# Pier 58 - Waterfront Park

This was the Seattle Design Commission's (SDC) second review of the Waterfront Park project. The concept design (30% design phase) was approved in 2014 when the project was reviewed under the name Central Public Open Spaces. The purpose of this meeting was to review the Schematic Design (60%). At this meeting, the SDC voted, 9-0, to approve the schematic (60%) design for the Pier 58 project.

January 7, 2021

Figure 2: Updated design proposal

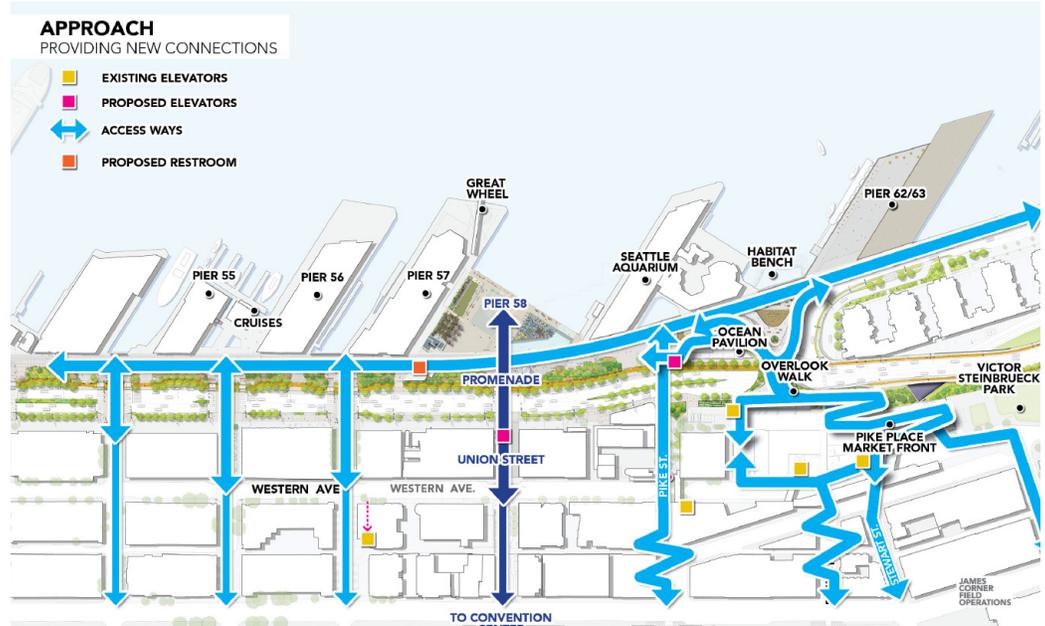
The SDC appreciated the overall layout and changes made the proposed design. Specifically, commissioners expressed appreciation for the addition of an opening to the water as well as its placement near the promenade, Aquarium and play area.'

The Commission also expressed their approval of the placement of the play area and the moves to provide views to the water with the choice of play equipment.

The SDC then discussed the proposed updates to the tree grove, open lawn, and open gathering space. Commissioners noted that the raised grove and lawn areas might allow for views to the play area for parents and caretakers. There was discussion about whether the grove and lawn space were sized correctly. Commissioners recognized that the tree grove will provide protection from sun and rain, also, depending on the type of artificial turf that is proposed, stabilized granite might be a more attractive material. The Commission then questioned the materiality of the stone seating along the western edge of the site. Commissioners commented that the stone appeared heavy, was an additional element to the material pallet, and would need to be thoughtfully considered in relation to the gathering space and the view to the water. The commission then recommended the project team reconsider the materiality of the seating, encouraging the team to consider a lighter material that would not present such a barrier in this location. Commissioners also recommended the team consider moveable seating options, similar to the large timber seating used elsewhere on the project site.

Figure 3: Proposed play structure design concepts: Above/Below (top), Pier Pile (middle), and Sea Dreams (bottom)

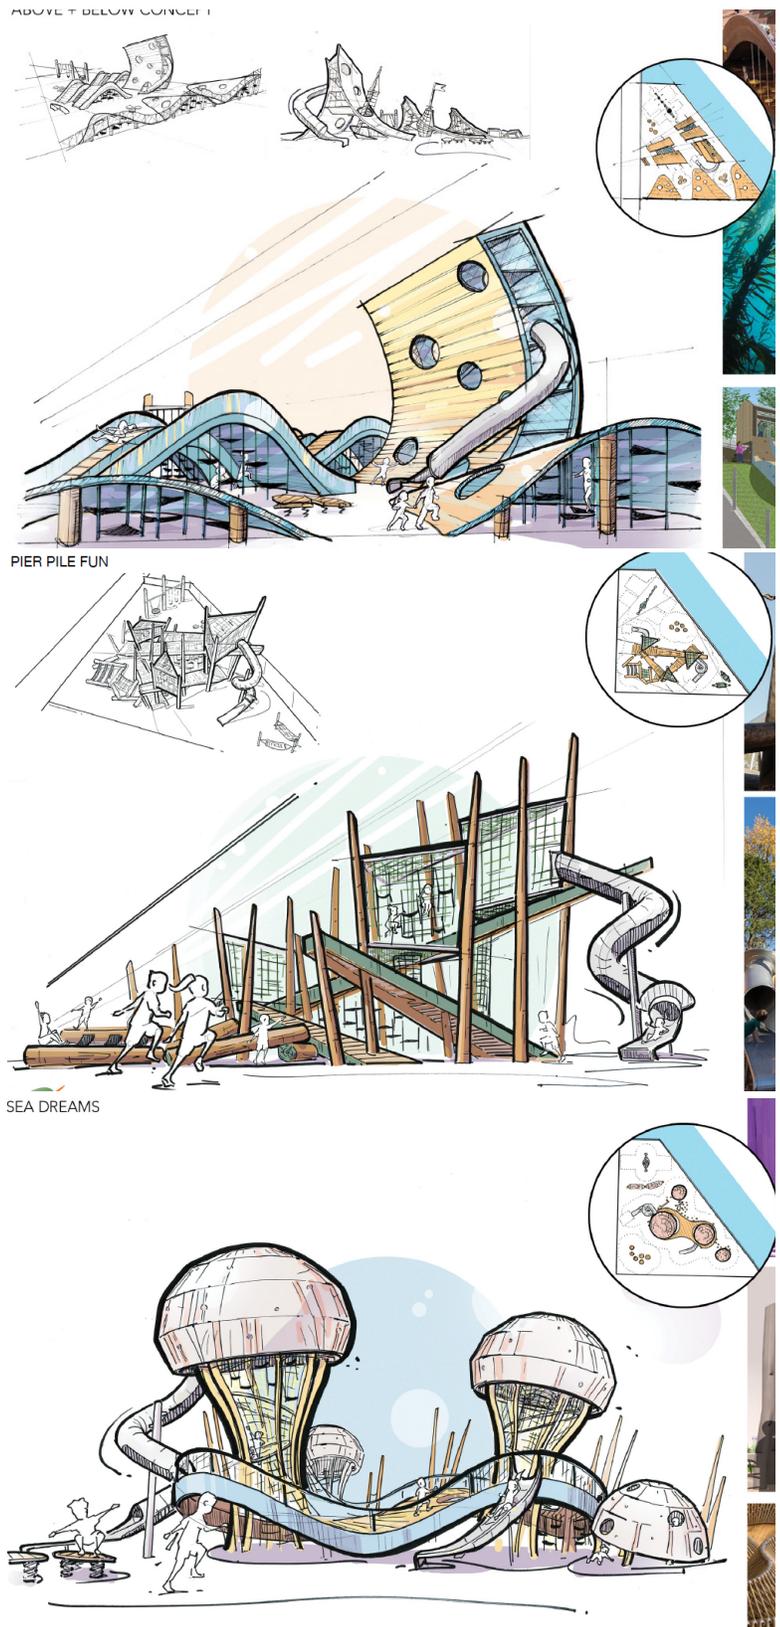
The SDC was very excited about the direction of the playground design. Commissioners noted the opportunities, importance, and complexity of the location of the play area. The Commission expressed their preference for the Sea Dreams and jelly fish design concept, as well as the overall idea to provide height so kids can see across the bay as well as activities happening within the park. Commissioners also appreciated the use of natural materials. While the play structure will not technically be art, The SDC acknowledged that the play structure will be a unique object, providing a memorable piece to be touched and interacted with. The Commission strongly recommended that the play structure continue to be developed to be a highly visible using light, shapes, and materials to provide for a unique and interactive experience. The Commission strongly encouraged the team to design for kids of all ages and abilities. While the play feature may be big and exciting, quieter pockets should be provided for children who don't want to be in the center of the action. Commissioners expressed a desire that the parents and caretakers be offered a quality experience and encouraged the team to provide for clear sight lines to the play area from other areas of the park. Commissioners suggested that the overwater location be capitalized on to enhance the relationship of play and the water. Commissioners then discussed whether it would be possible for the play area to connect to the open water area in some way.

7. Continue to design the playground as a unique, special feature. Consider its interface with the open water area. Provide spaces for children of all ages and abilities, including more calm, quiet pockets.
